WELL NO. CISCO FEDERAL #20 API NO. 43-019-30740

APPLICATION FOR PERMIT TO DRILL, DEEPEN, OR PLUG BACK

Subject: Application to Drill: U-31747
Cisco Dome #20
Section 6, T. 20 S., R. 22 E.
Grand County, Utah

STIPULATIONS FOR THE CISCO DOME #20 WELL SITE

PLAN FOR PRODUCTION EQUIPMENT
CISCO DRILLING & DEVELOPMENT CO.
CISCO WELL # 11
SE 1/4 SW 1/4 Sec. 6, T.20S., R.22 E.
SALT LAKE MERIDIAN

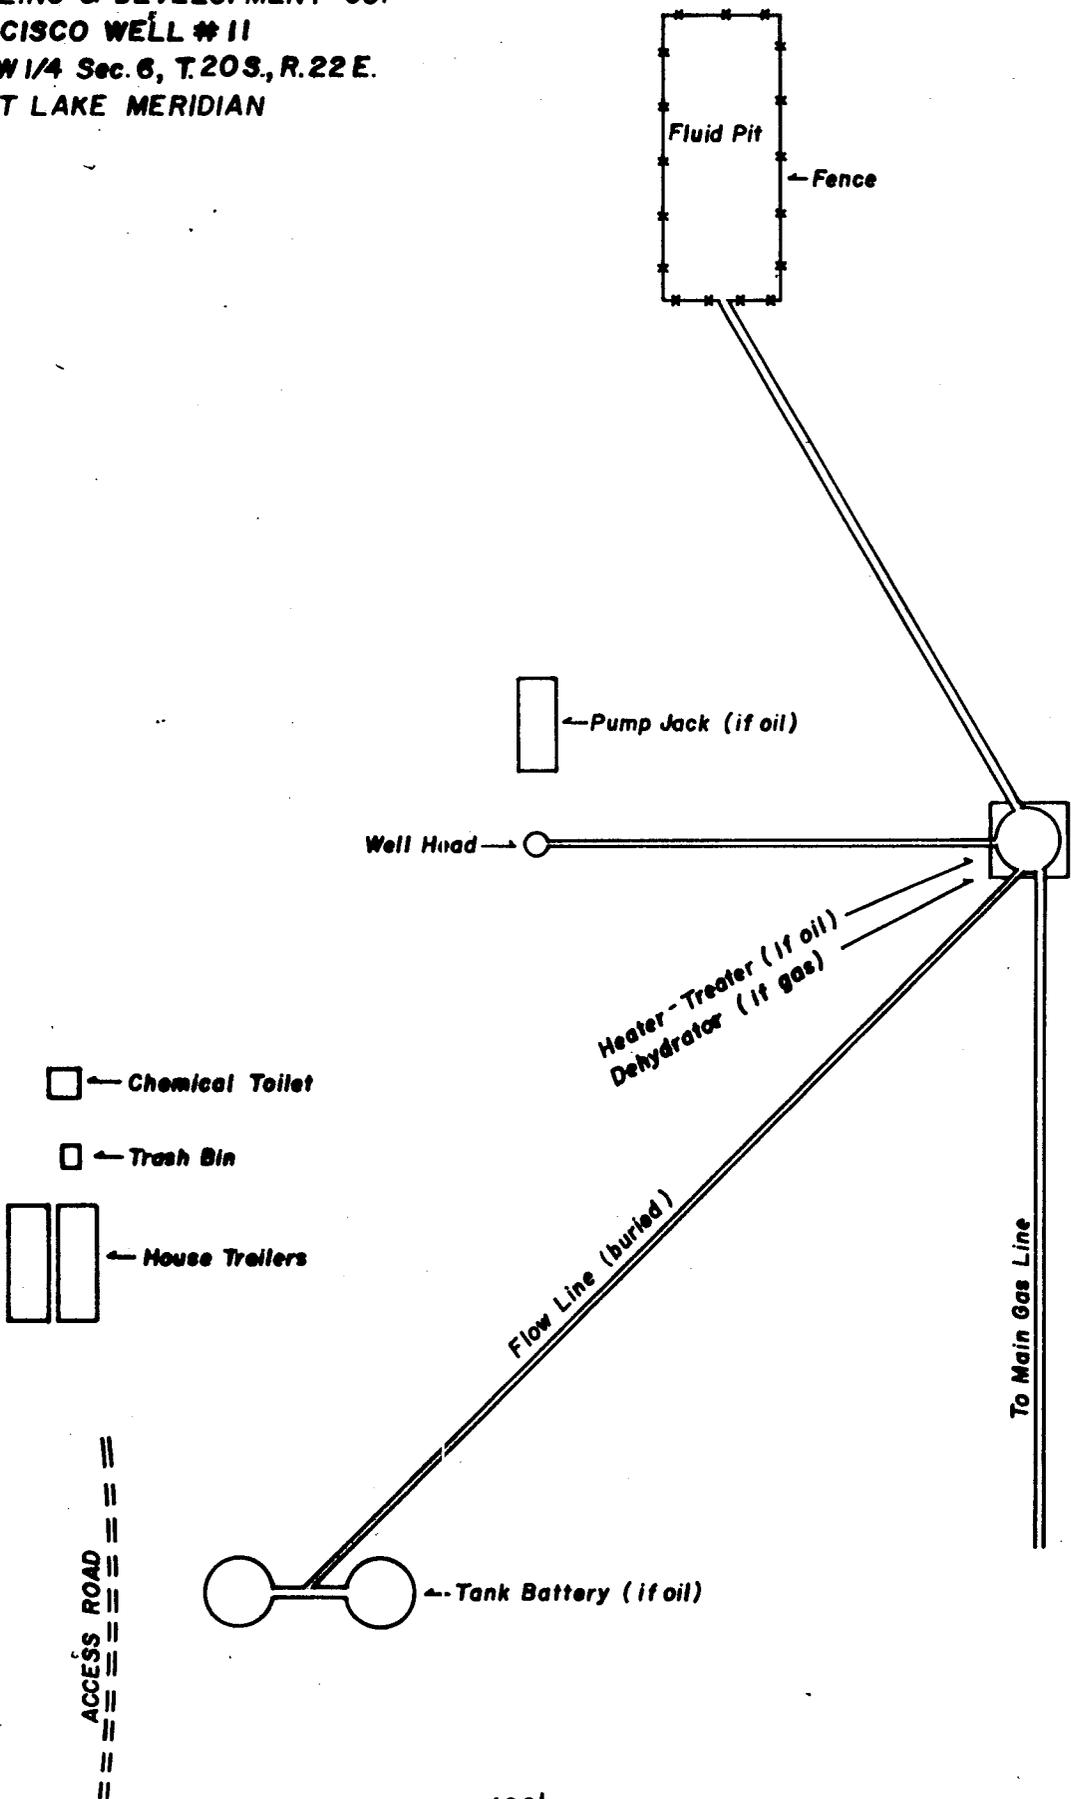
Production Facilities and Flowline NOT Approved

6. Producer:
 - A) The access road will be upgraded to permanent road specification so to facilitate tank truck traffic.
 - B) Production facilities are not approved at this time.

Figure 1. Reserve Pit Construction in Areas of Environmental Concern

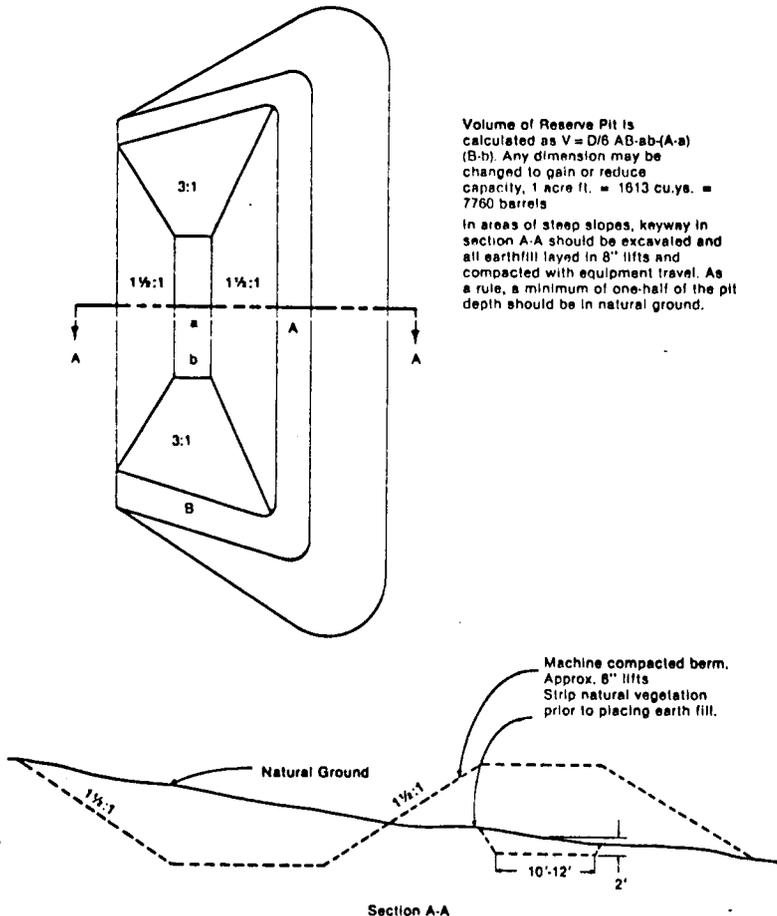
4. The reserve pit should be constructed with a keyway and constructed similar to the enclosed reserve pit construction diagram (Fig. 1). This should prevent the potential for reserve pit leakage on this particular landform.

FIGURE 2 Standard woven wire, sheep-light fence

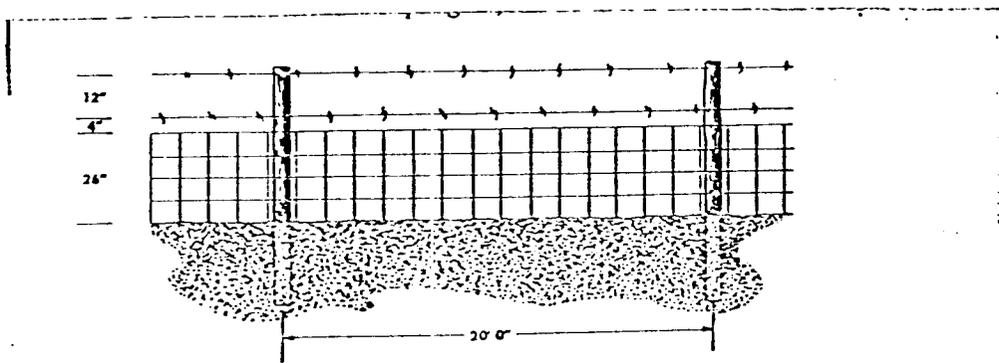
5. Because of the presence of trailing sheep in this area, a woven wire sheep-tight fence (26" standard woven wire, two barbed-wire strands on top, (Fig. 2) will be constructed around the reserve pit.
